## Product Change Notice (PCN)

件名: RH850 シリーズの蘇州、錦組立品のリードフレーム標準化およびサポートテープ標準化

発行日: 4/24/2025

変更前リードフレーム

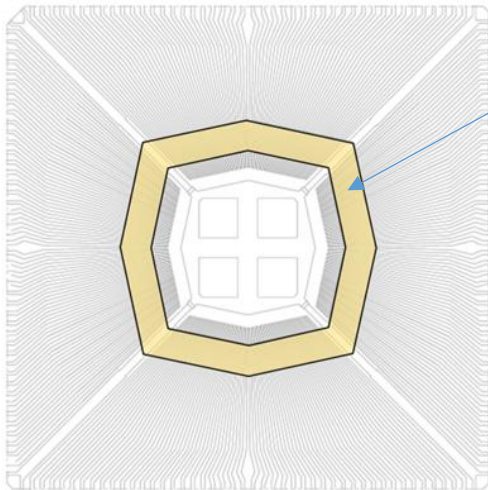
従来リードフレームおよび従来サポートテープ品

変更後リードフレーム

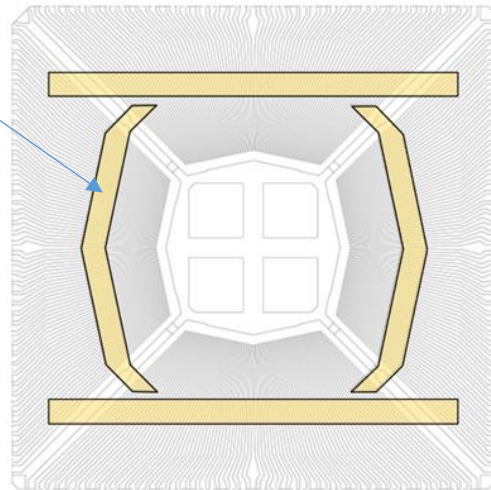
標準リードフレームおよび標準サポートテープ品

サポートテープ

※サポートテープはリードフレームメーカーで貼付けします。

変更前リードフレーム (例: 176pin)

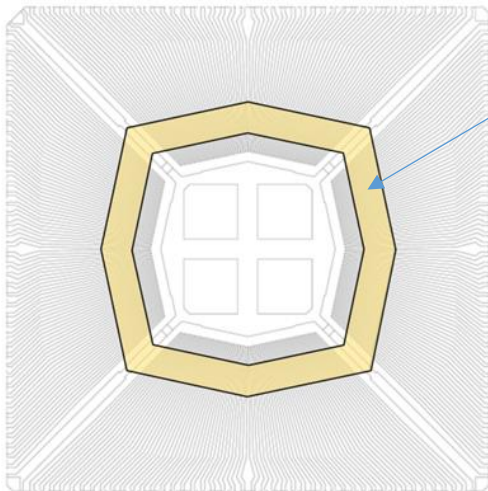
従来サポートテープ品

変更後リードフレーム (例: 176pin)

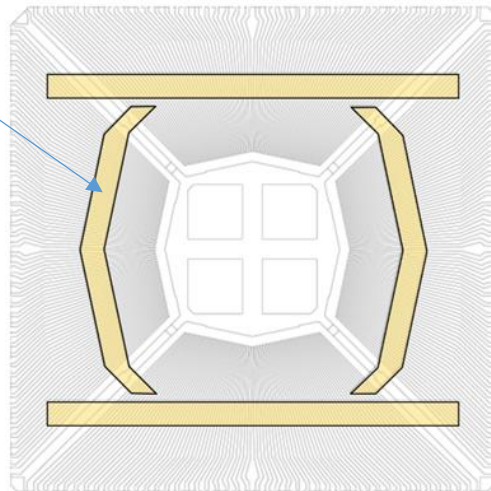
標準サポートテープ品

サポートテープ

※サポートテープはリードフレームメーカーで貼付けします。
